SAN FRANCISCO PLANNING DEPARTMENT

NOTICE OF PUBLIC HEARING

PROJECT INFORMATION	APPLICANT INFORMATION
Project Address: 34 Steiner Street Cross Street(s): Hermann Street Block /Lot No.: 0875 / 013 Zoning District(s): RTO / 40-X Area Plan: Market and Octavia Record Number: 2019-0002272VAR	Applicant: Toby Morris Company: Kerman Morris Architects Applicant Address: 139 Noe Street City, State: San Francisco, CA 94114 Telephone: (415) 749-0302 E-Mail: toby@kermanmorris.com

PRE-APPLICATION MEETING REQUEST
34 Steiner Street.
Alterations
Existing: 7-Unit Residential
Proposed: 9-Unit Residential
2016 California Building Code
BPA #2018-0912-9872

EGRESS / PATH OF TRAVEL SITE PLAN

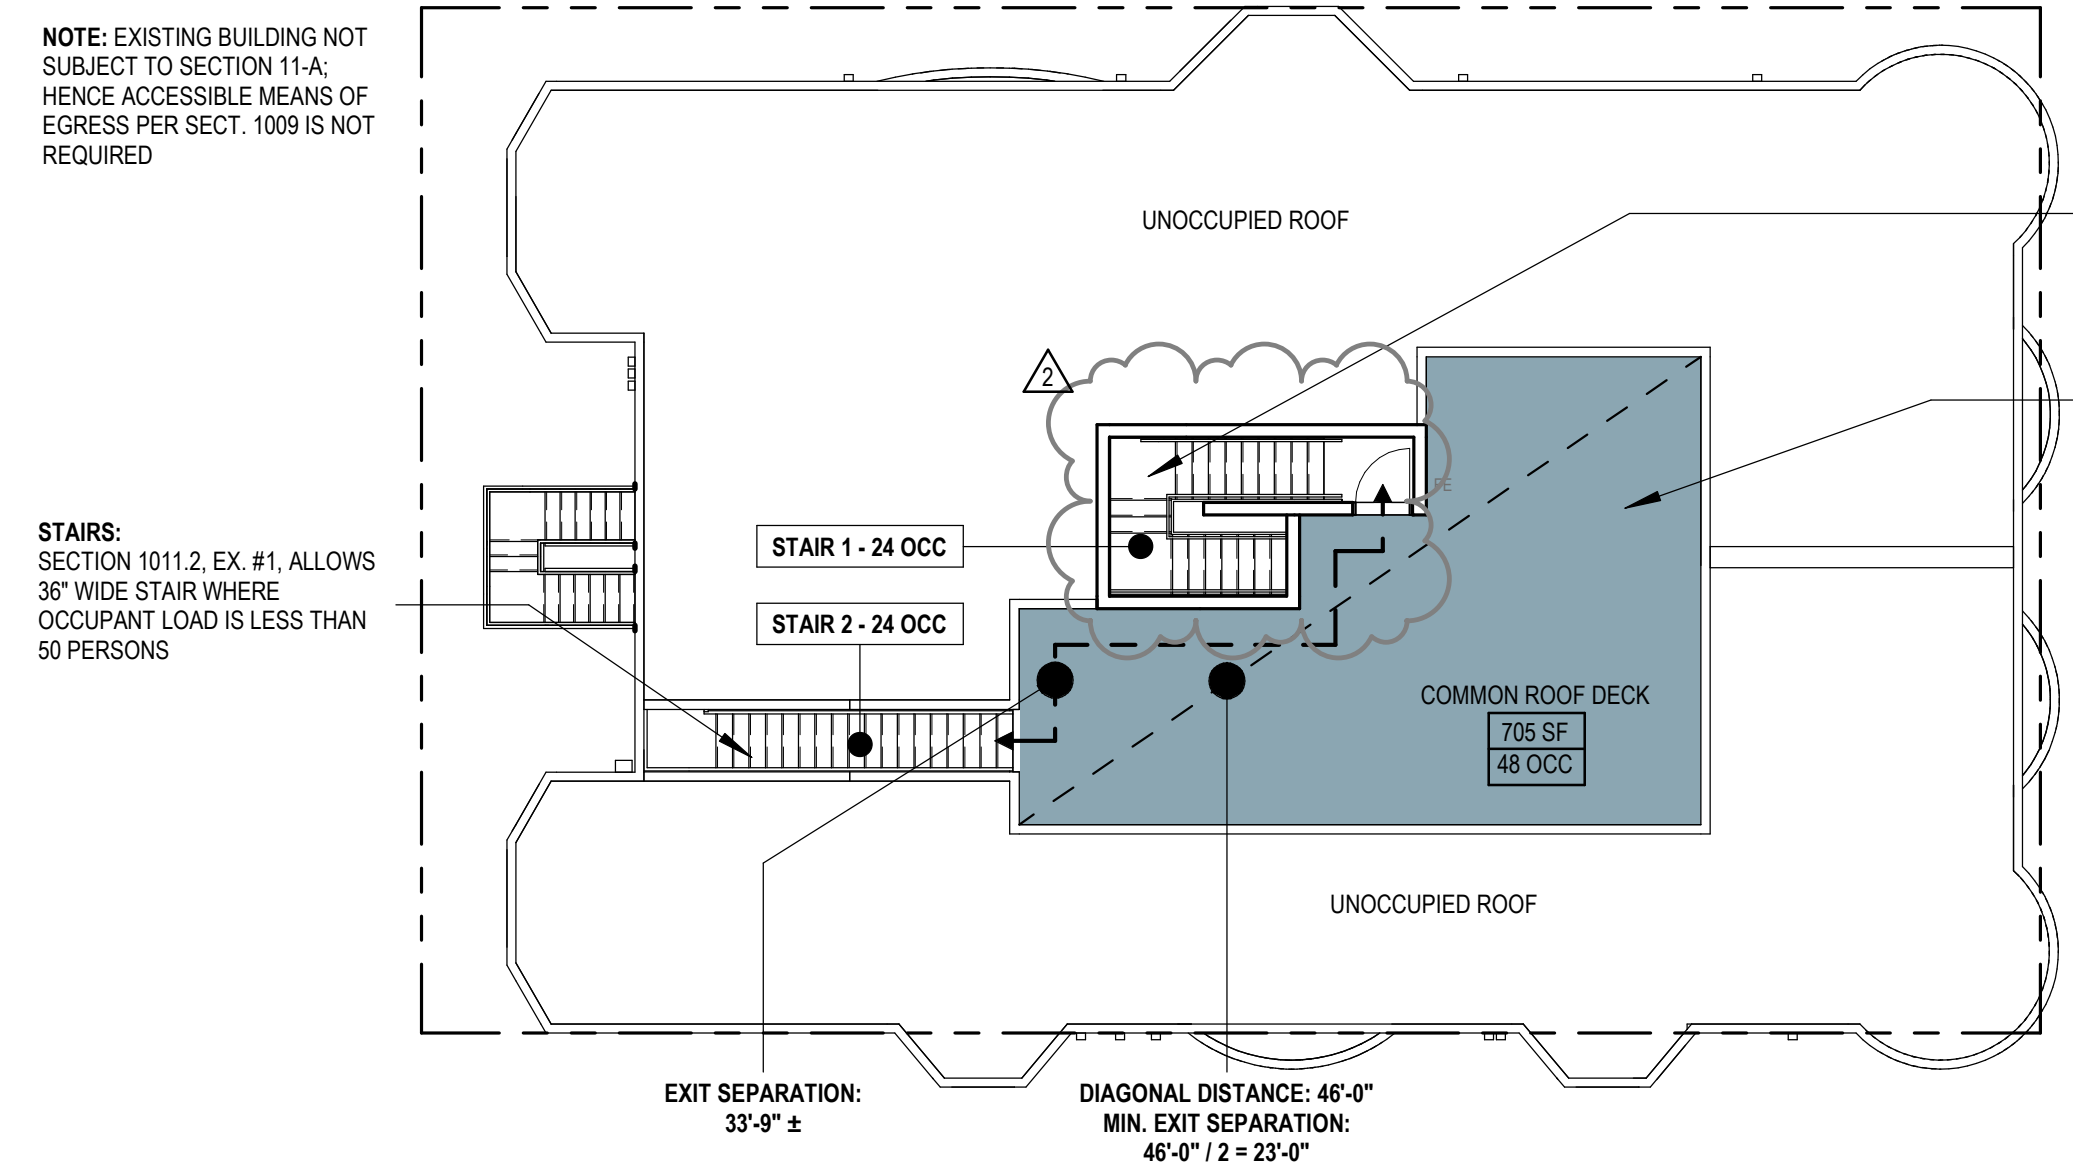
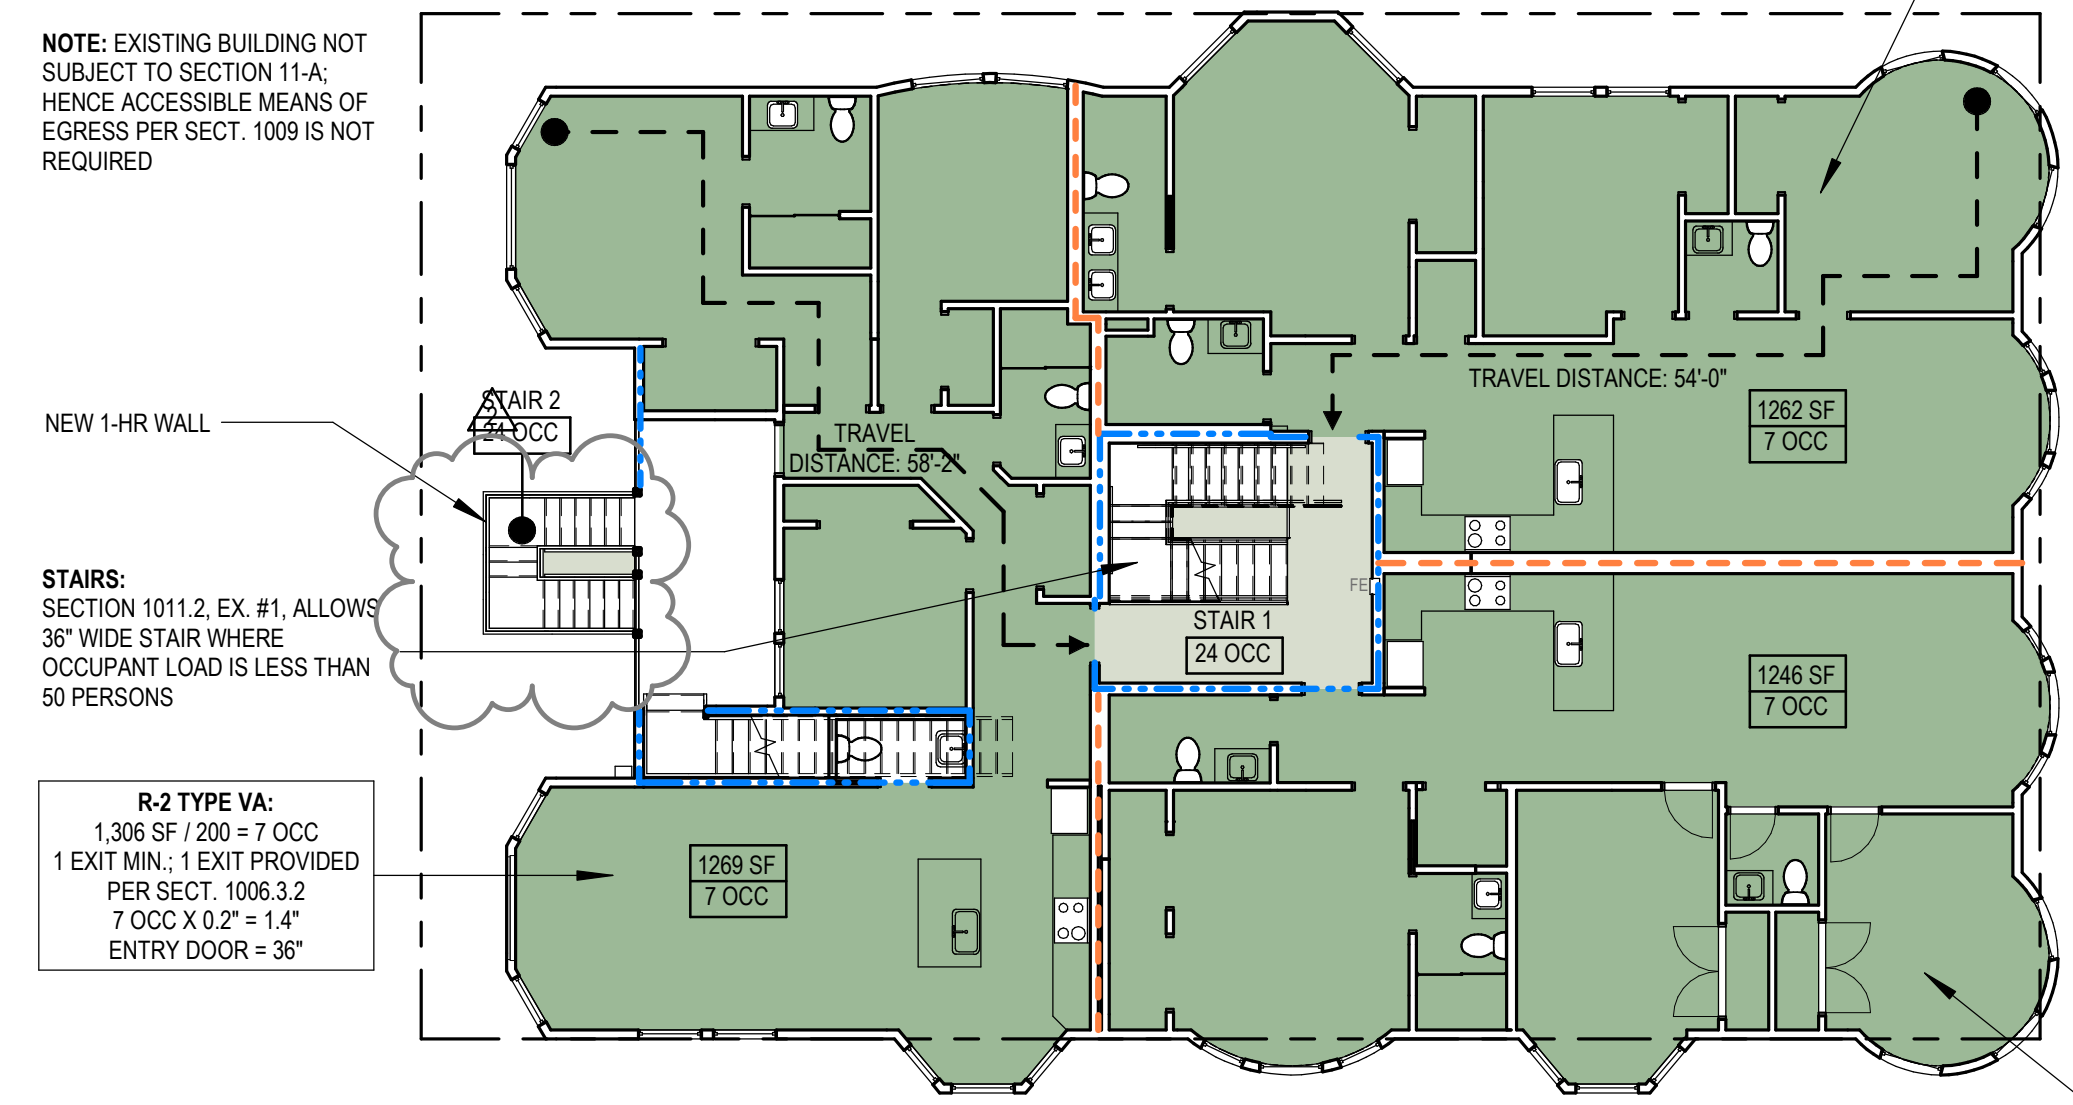
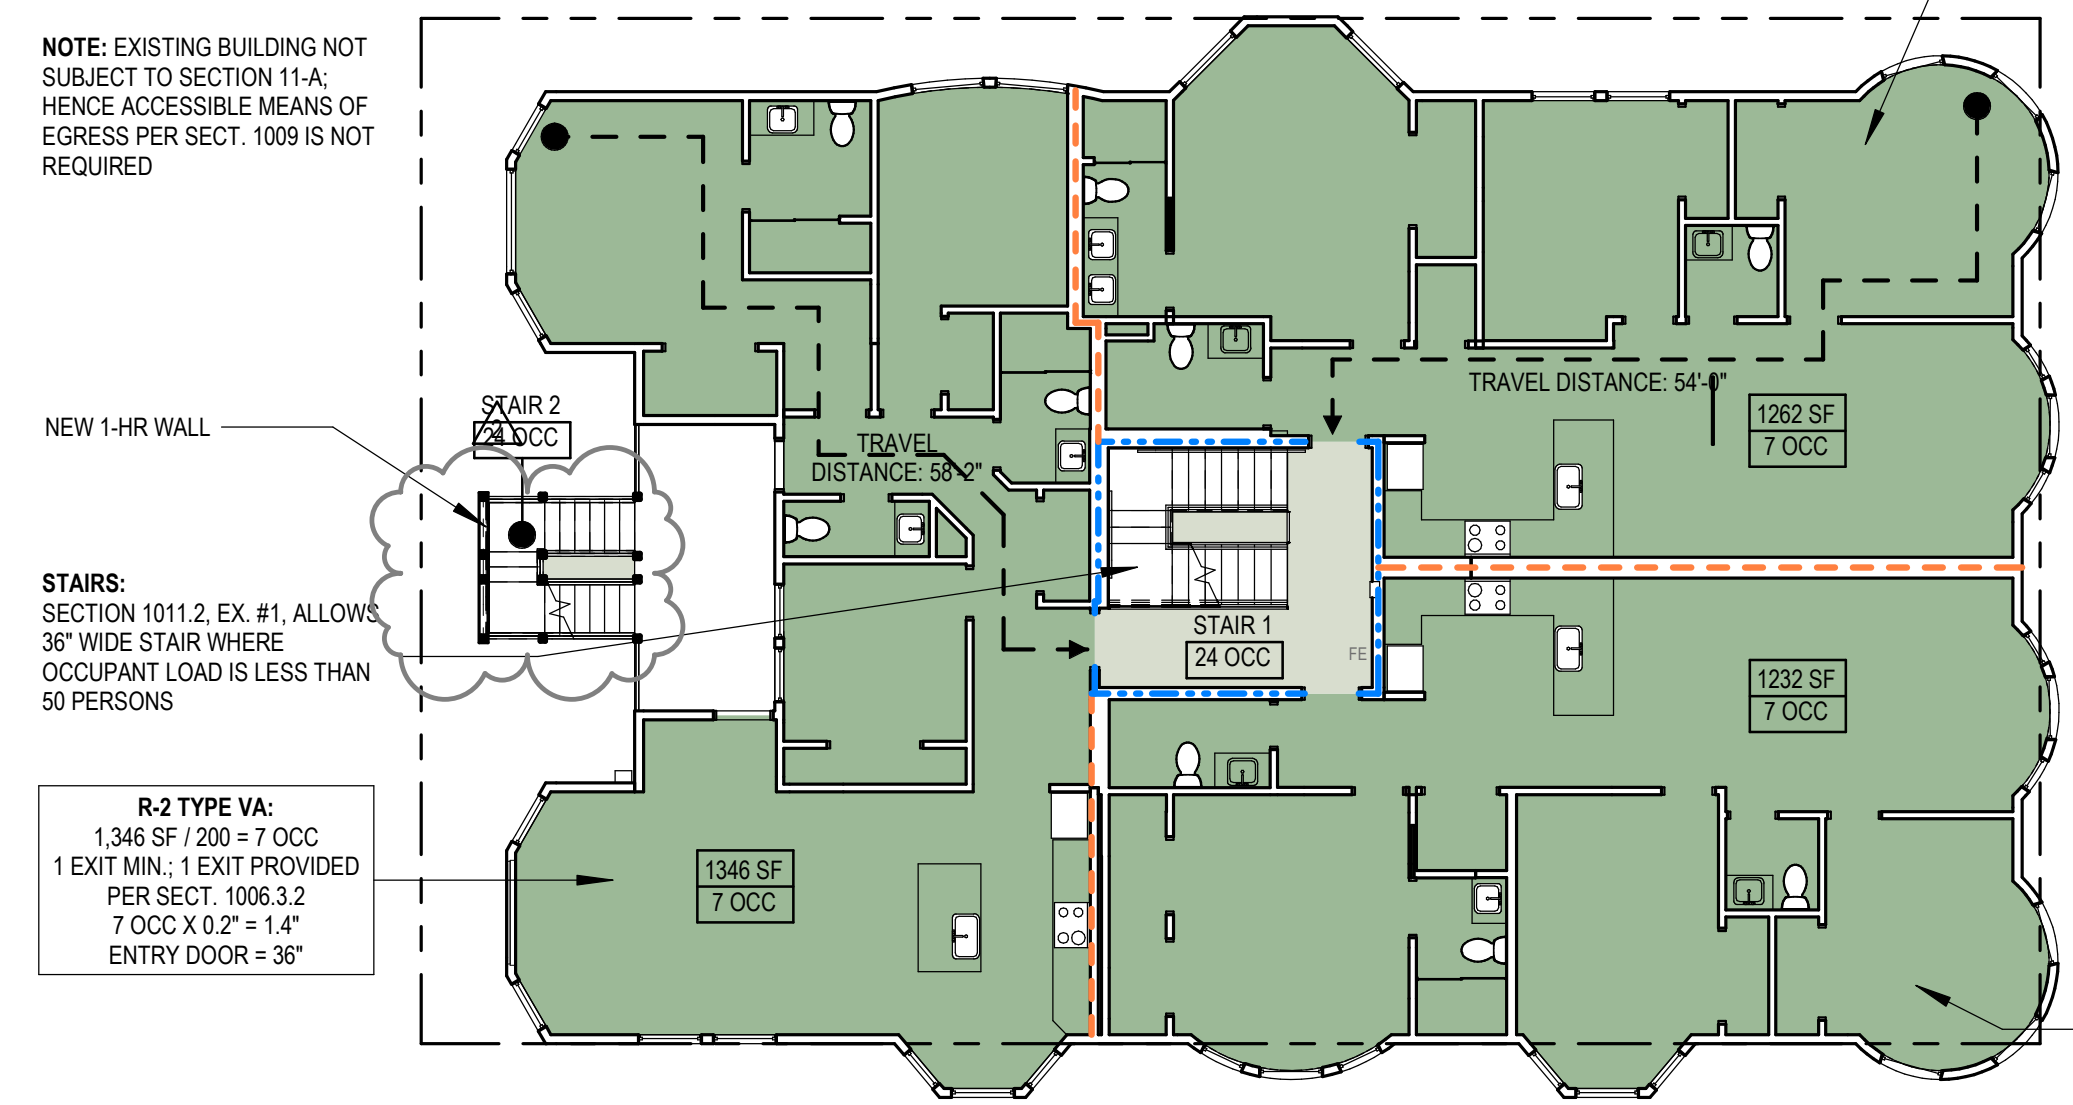
The existing partially excavated basement is proposed for full excavation and new foundations (see A2.01) to provide for storage (occupant load 300). See G0.03 Existing Plans. The basement is proposed to have 2 exits (serving approximately 13 occupants); the exits are separated by 1/3 the overall diagonal dimension of the basement area served per section 1007.1.1, exception #2 in this fully sprinklered building. Please confirm that the proposed 2 exits are sufficient.

Confirmed: Subject to review at Plan Check.
